Editor's Report – Proposal Summary

George Zimmerman / CME Consulting, Inc.

11/18/2020

147.3.3 PCS Receive State Diagram changes

Figure 147-7 (excerpt)

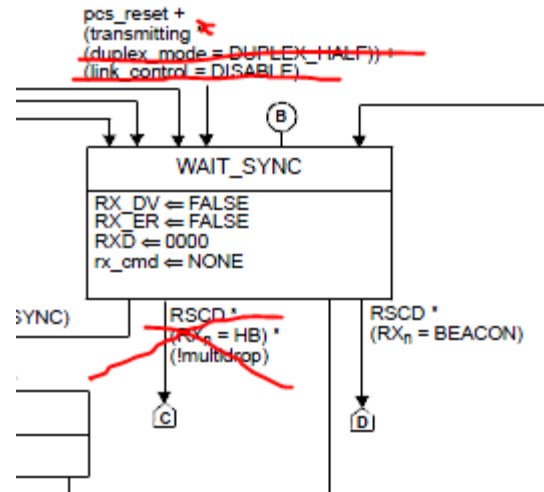
- Fig 147-7: delete exit “C” from WAIT_SYNC; Fig 147-8: delete “HEARTBEAT” states that “C” goes to

DO NOT
DELETE
LINK
CONTROL
